ZC Case No. 15-28 - PUD Modification
Address: 301 N St NE Washington, DC 20002

FILLAT+ ARCHITECTURE
PLAN REVIEW - PRESENTATION

PRESS HOUSE HOTEL
24006 - 301 N St NE Washington, DC 20002

ZONING COMMISSION
District of Columbia
CASE NO. 15-28A
EXHIBIT NO. 20B1
FILLAT+
ARCHITECTURE

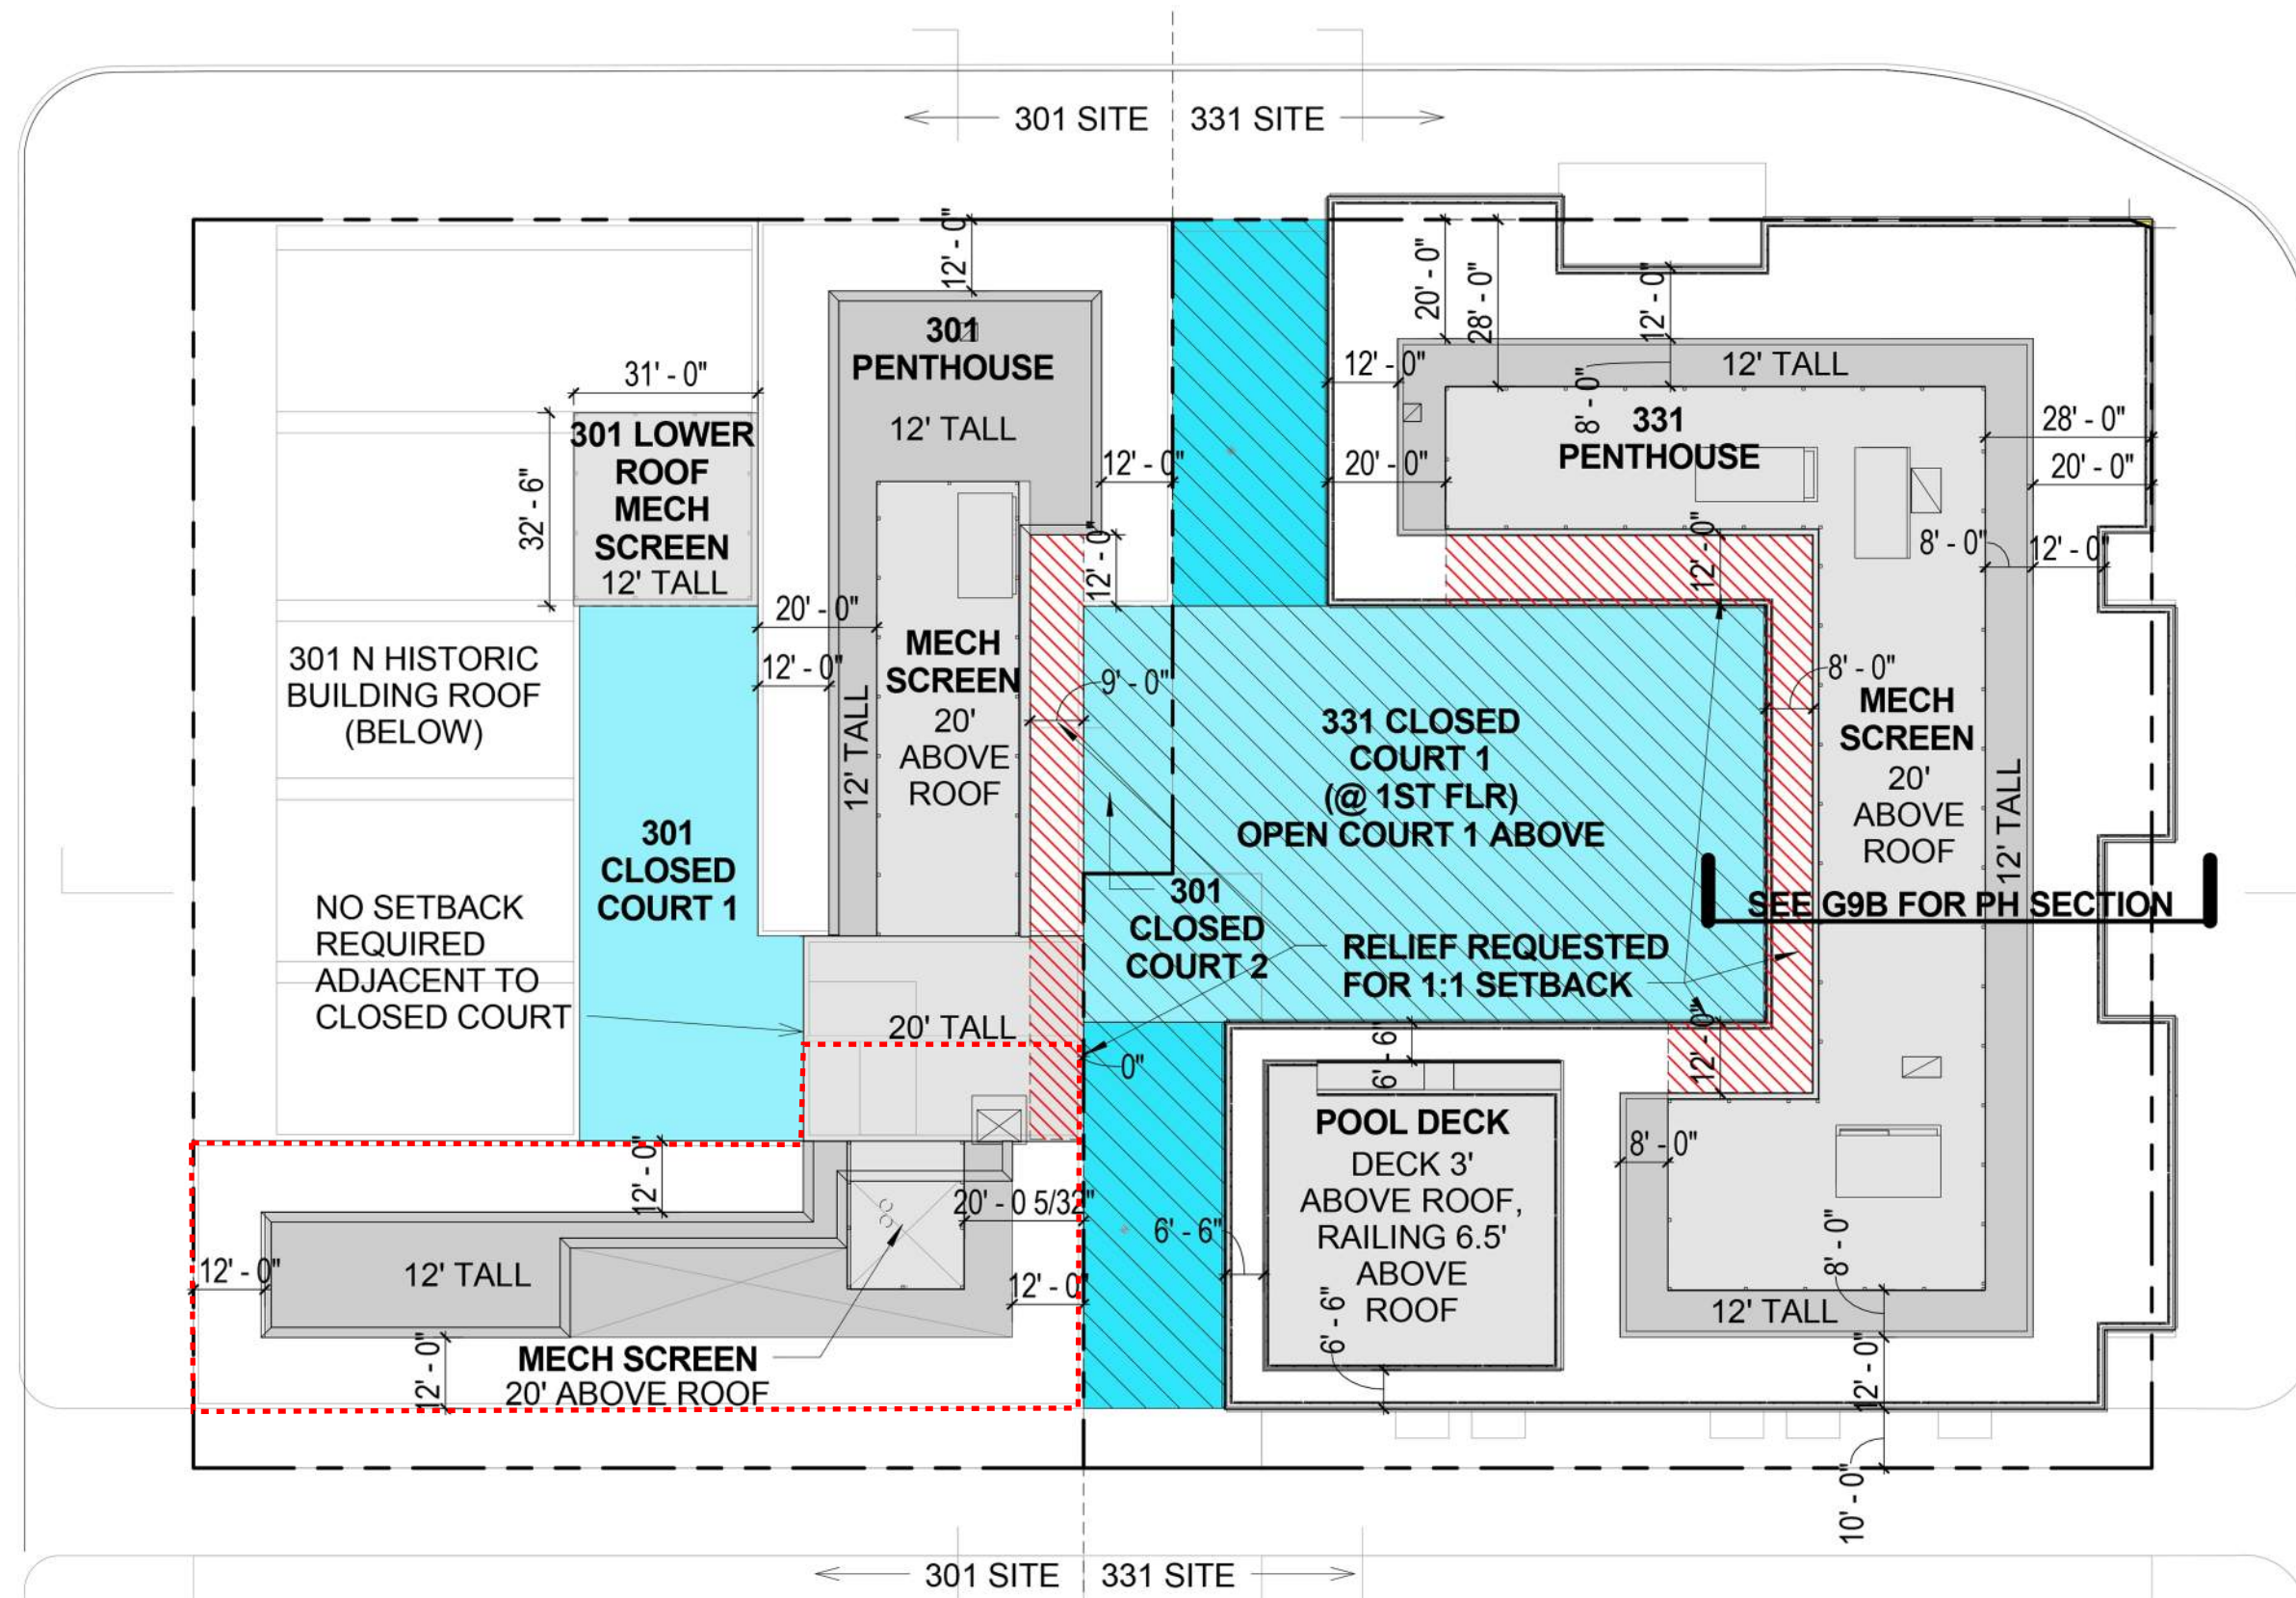
Per Subtitle A, Section 102.4, "a modification to a vest project (other than a minor modification) shall conform with the 2016 Regulations as the 2018 Regulations apply to the requested modification. As such, the development standards of ZR16 have been applied to the hotel on the 301 N portion of the PUD since that is the only part of the previously-approved PUD that is subject to the modification. Adjustments to zoning tabulations resulting from PUD modification shown in red.

Flexibility is requested to vary the number of hotel rooms on the 301 N portion of the PUD by +/-10%

Under ZR16, the loading requirement for the hotel increased from one berth to two berths. Pursuant to Z.C. Order No. 15-28, Conclusions of Law 6, the Commission granted flexibility for loading to allow shared loading between 301N and 331N, with all loading facilities located within 331N, which has been constructed with two berths and one delivery space. Thus, additional flexibility is not required for the proposed modifications to the hotel.

Pursuant to Z.C. Order No. 15-28, Conclusions of Law 6, the Commission granted flexibility for penthouse setback. Additional flexibility is not required for the expanded mechanical penthouse on the east side of the hotel building. Since the Commission approved the initial PUD, the penthouse regulations have been amended. Currently, per Subtitle C, Section 1504.1(c)(3), a 1:1 setback is only required along a side building wall when the adjacent property along the shared side lot line has a lower permitted matter-of-right building height. Since both 301N and 331N were rezoned to the same zone as part of the approved PUD, and thus may achieve the same matter-of-right building height, a 1:1 penthouse setback is not required along the shared side lot line.

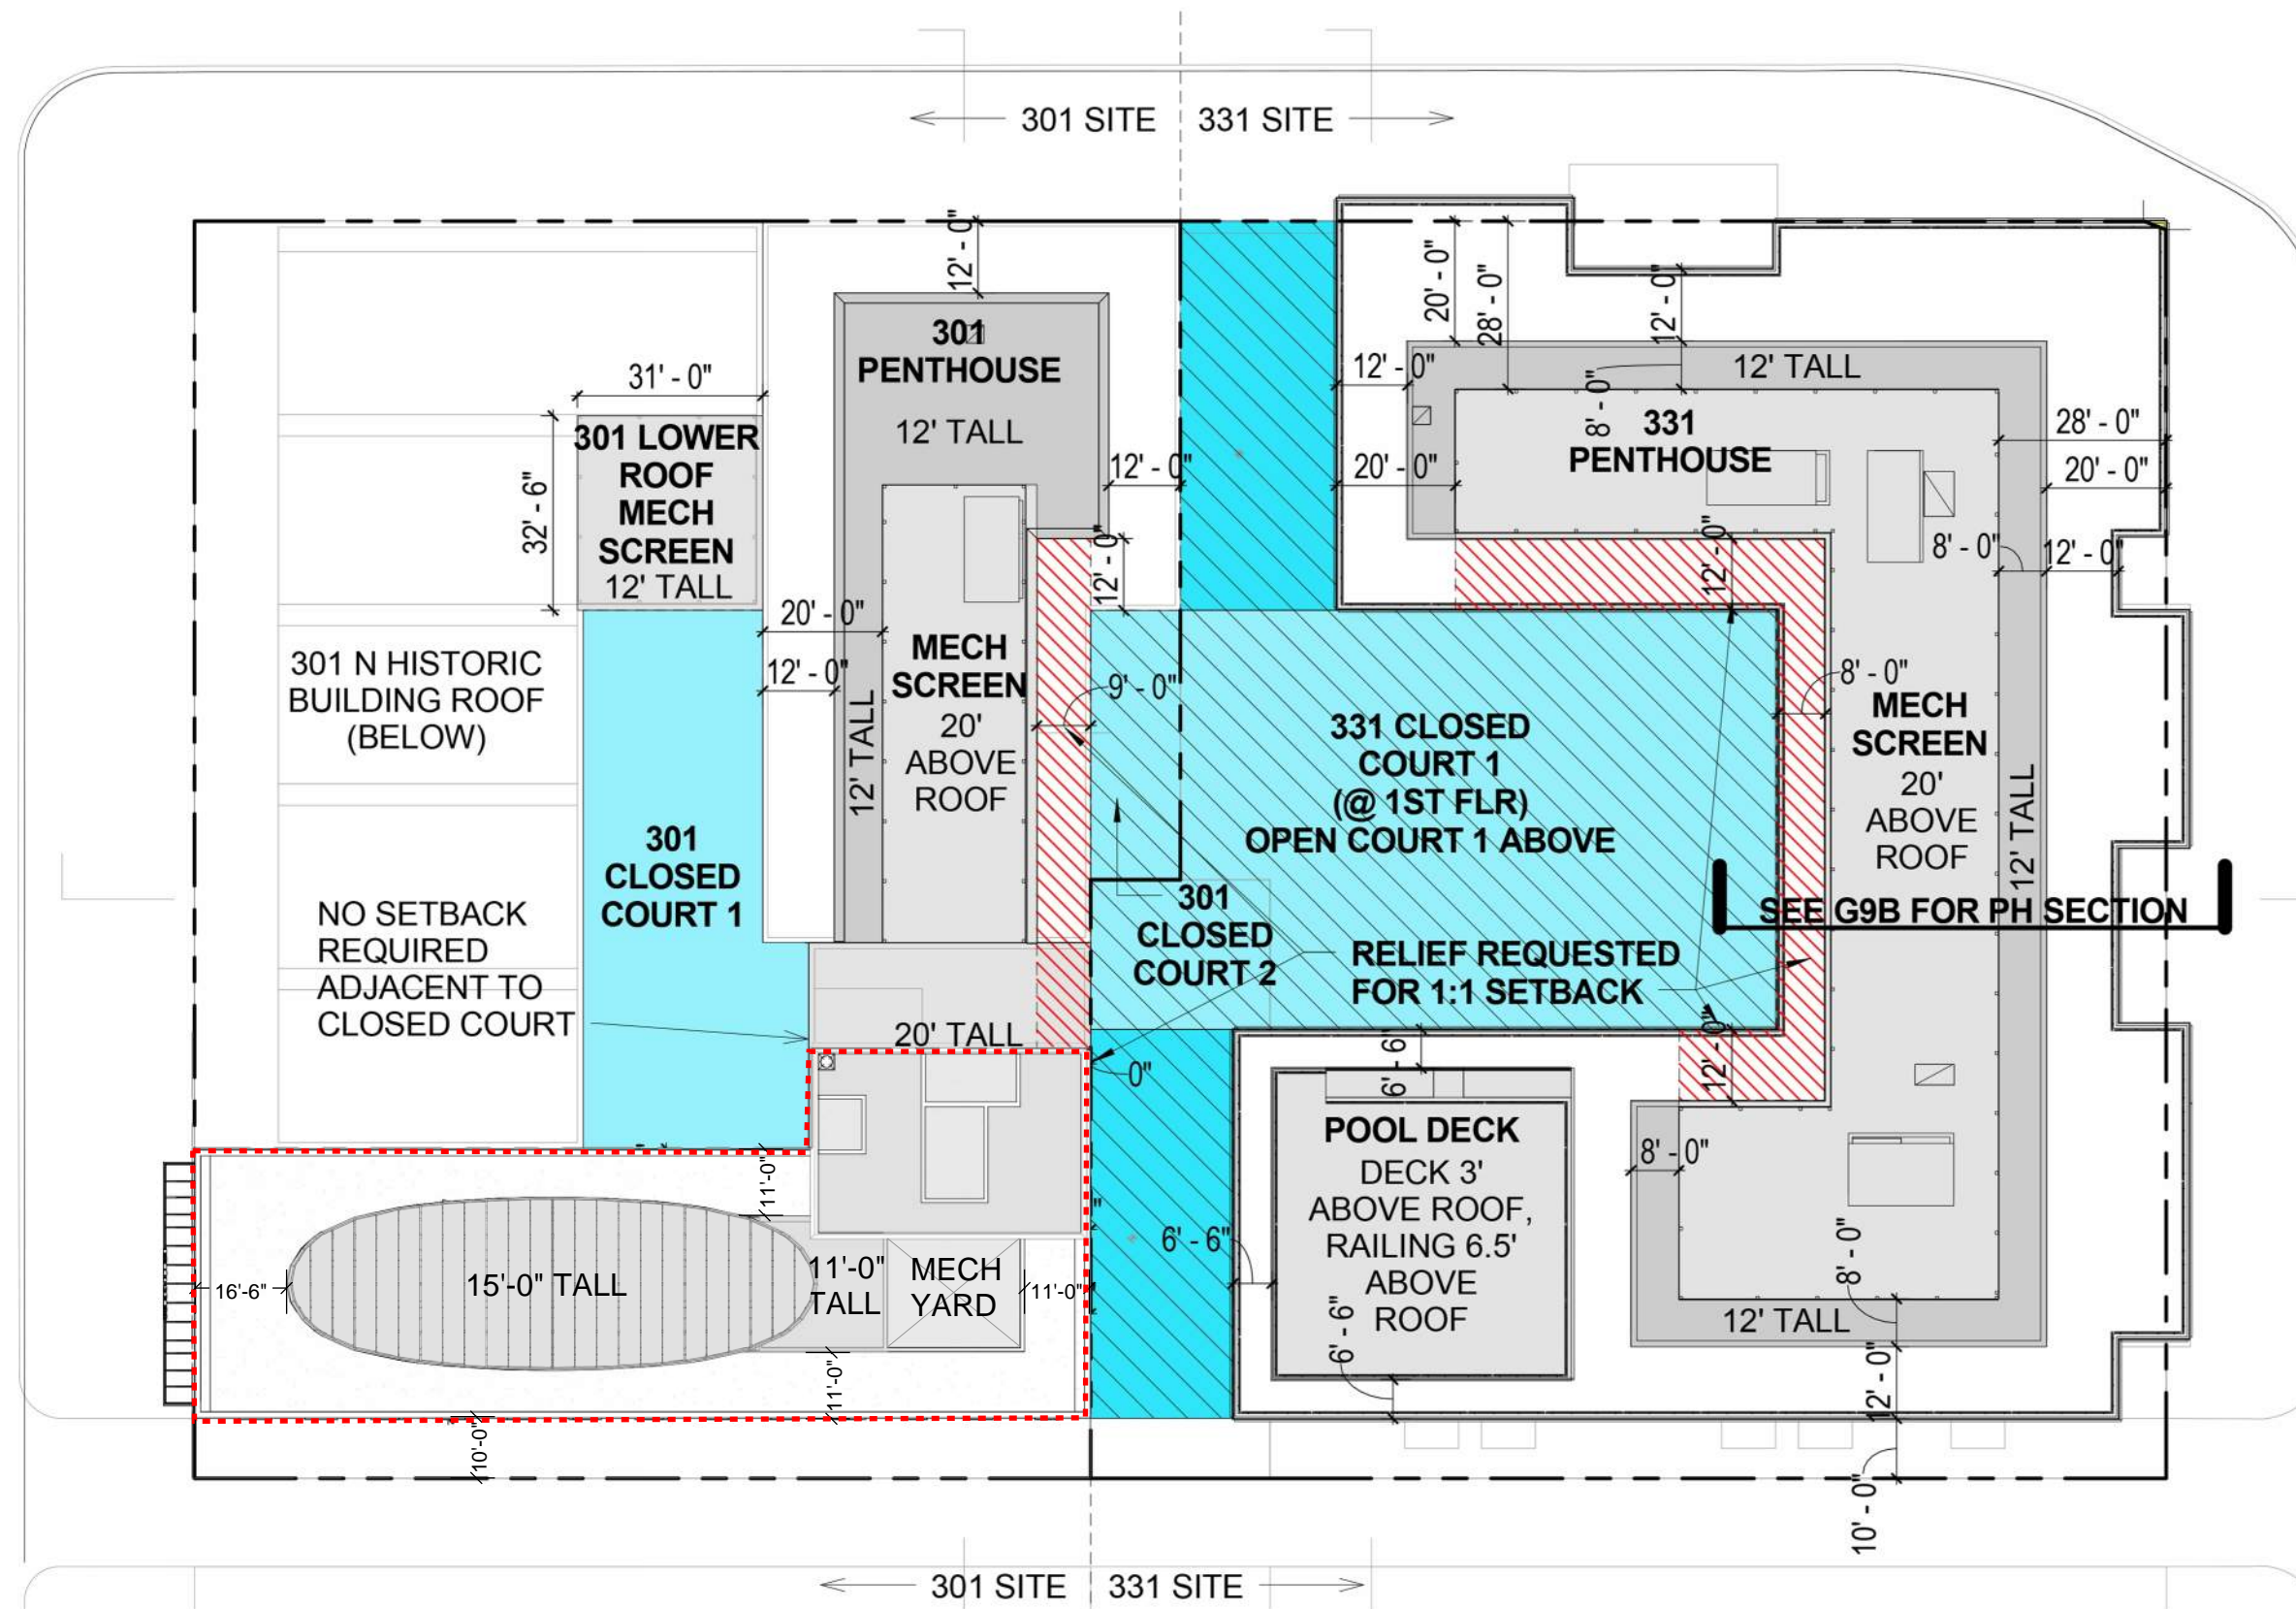
Pursuant to Z.C. Order No. 15-28, Conclusions of Law 6, the Commission granted flexibility for penthouse setback. Additional flexibility is not required for the expanded mechanical penthouse on the east side of the hotel building. Since the Commission approved the initial PUD, the penthouse regulations have been amended. Currently, per Subtitle C, Section 1504.1(c)(3), a 1:1 setback is only required along a side building wall when the adjacent property along the shared side lot line has a lower permitted matter-of-right building height. Since both 301N and 331N were rezoned to the same zone as part of the approved PUD, and thus may achieve the same matter-of-right building height, a 1:1 penthouse setback is not required along the shared side lot line.

DASHED RED AREA INDICATES PORTION OF ROOF WHERE PENTHOUSE ENCLOSURE DOES NOT MEET 1:1 SETBACK
